COTTAGE GROVE PLANNING COMMISSION

February 24, 2025

STAFF REPORT CASE: CUP2025-007

Planning Staff Report

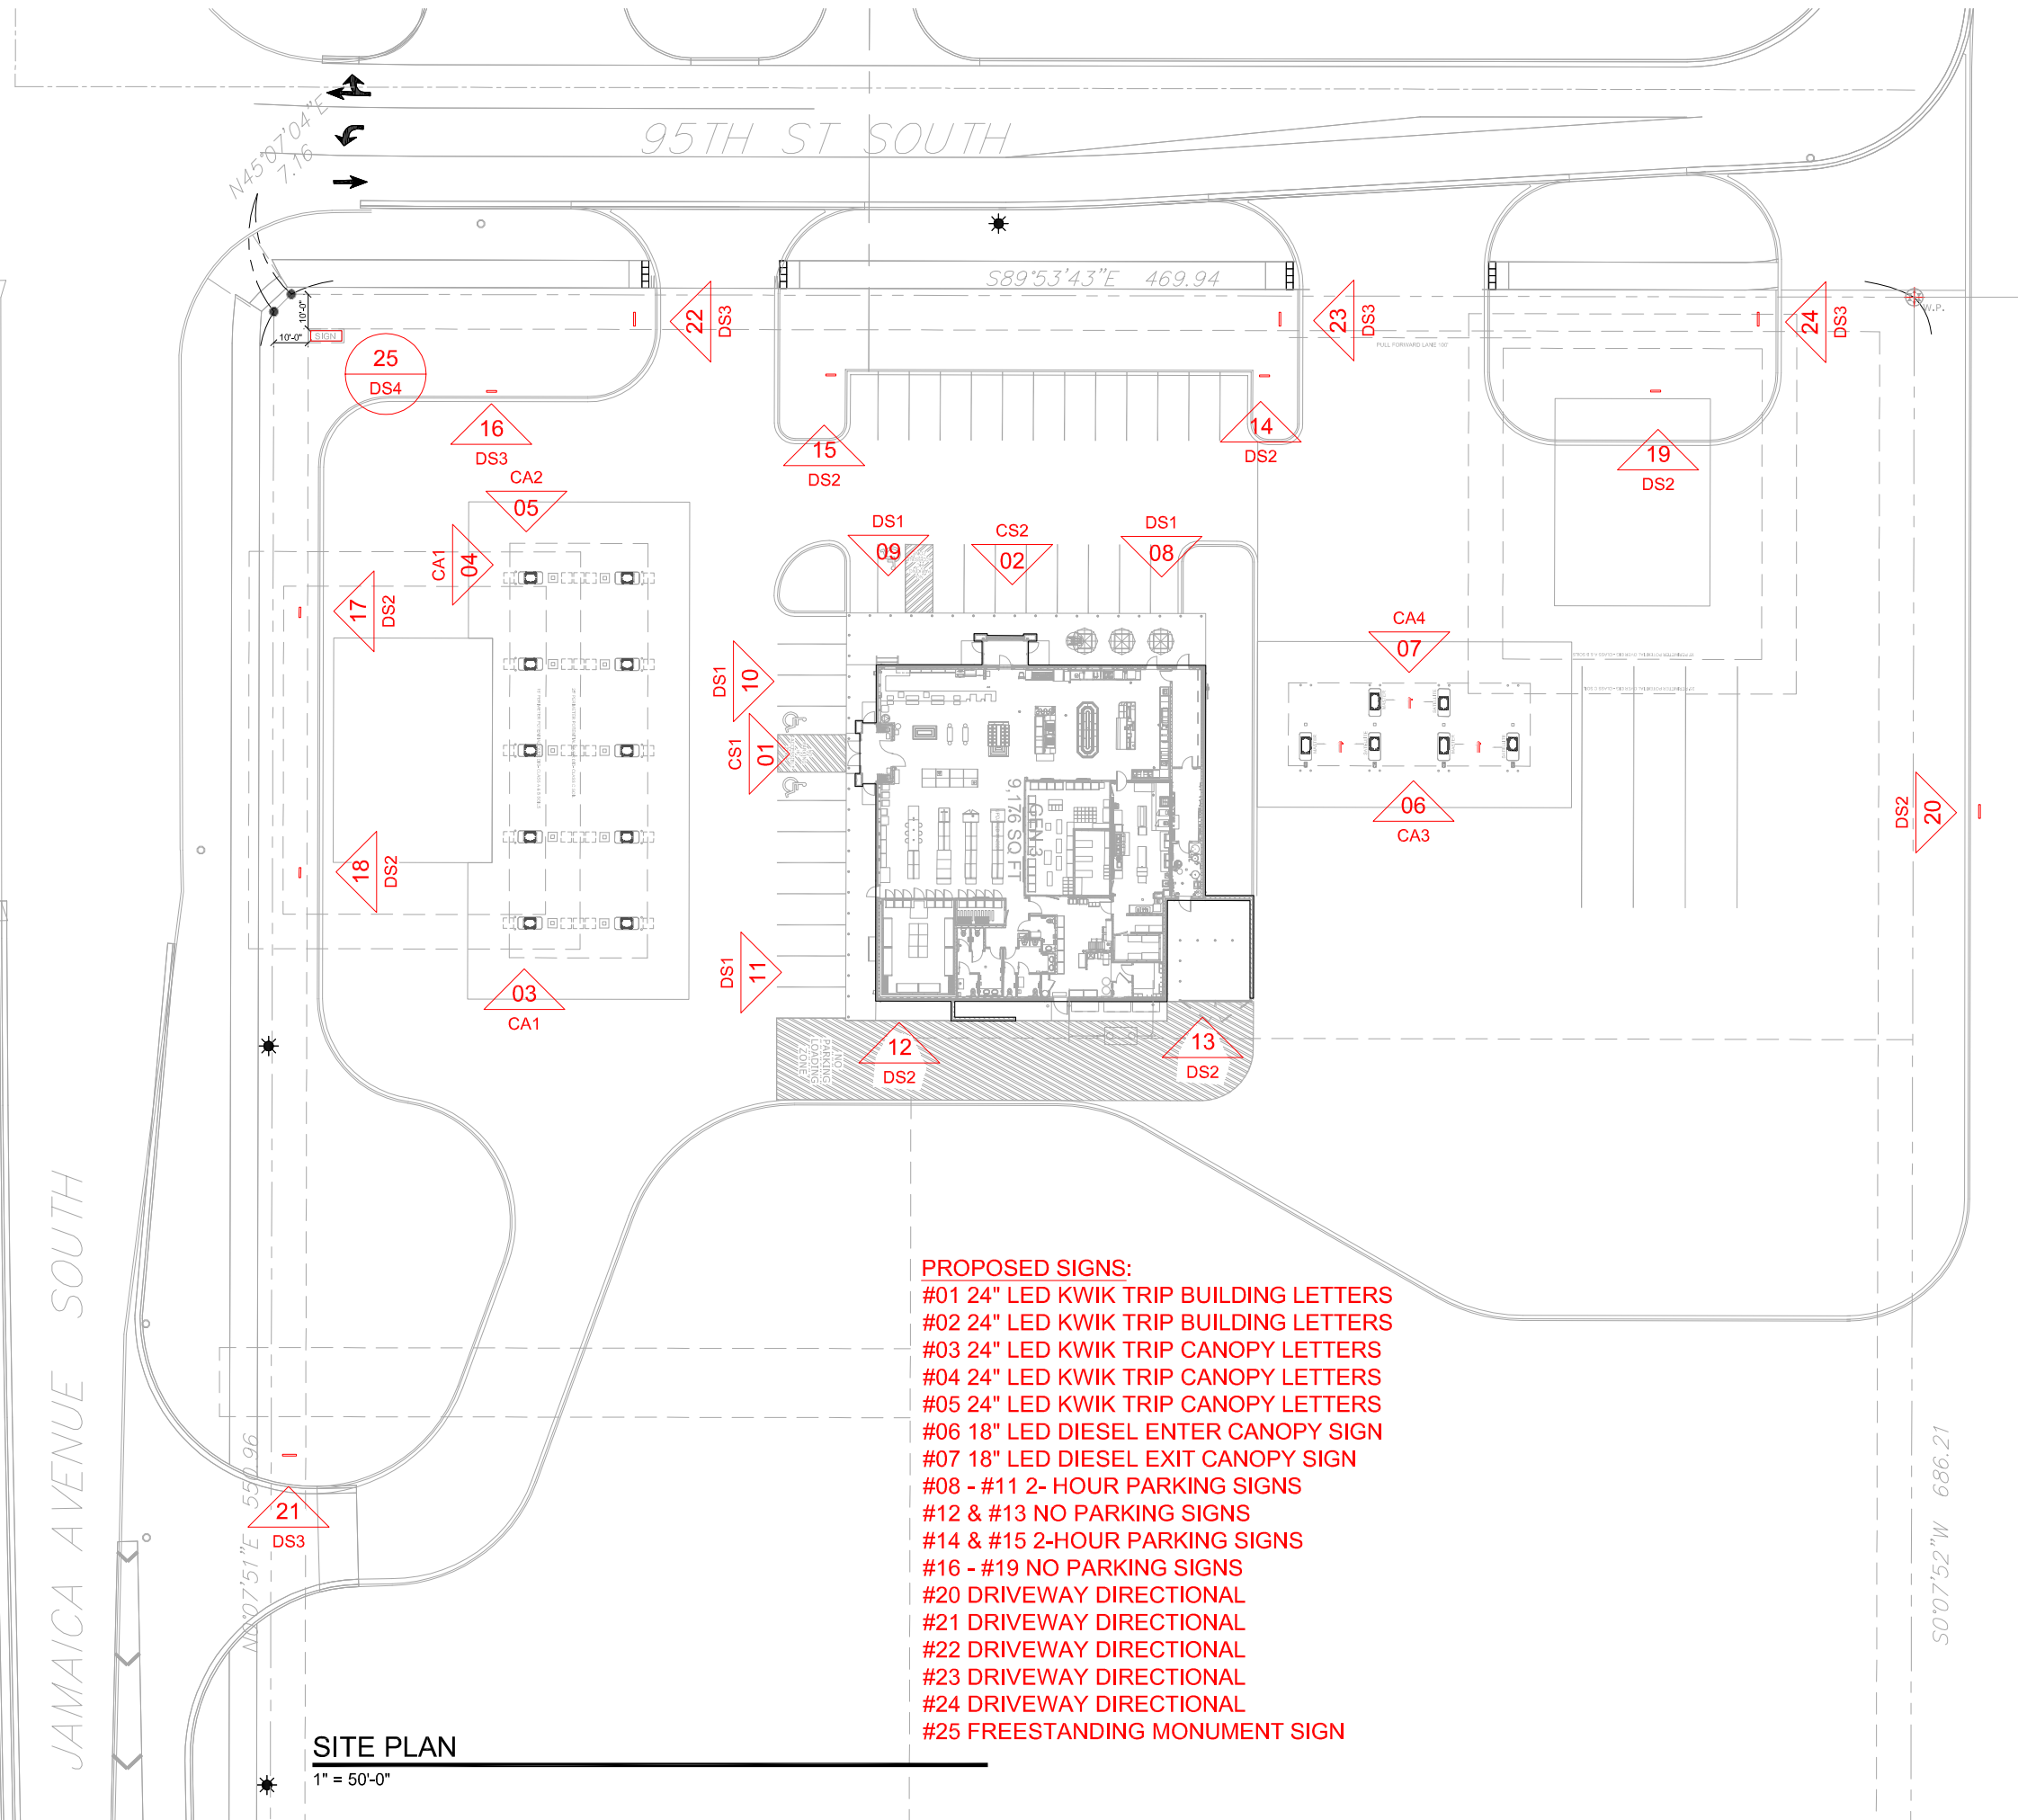
- a. Sheet C300 shows an 18" HDPE from MH 9 to CB 2. This pipe is listed as 15" HDPE in the storm sewer design table. Please check and correct the plan sheet as necessary.

- b. Sheet C300 shows a 30" HDPE at 0.5% from CB2 to the FES. The Manning equation full flow design velocity of this pipe is 7.7 feet per second. Please adjust the pipe sizes and slopes so the outfall design velocity of this pipe is 6 feet per second or less to limit erosive potential.

- c. Sheet C300 shows a 15" HDPE at 3.95% from OCS#12 to FES apron #1. The Manning equation full flow design velocity of this pipe is 13.6 feet per second. Please adjust the pipe sizes and slopes so the outfall design velocity of this pipe is 6 feet per second or less to limit erosive potential.
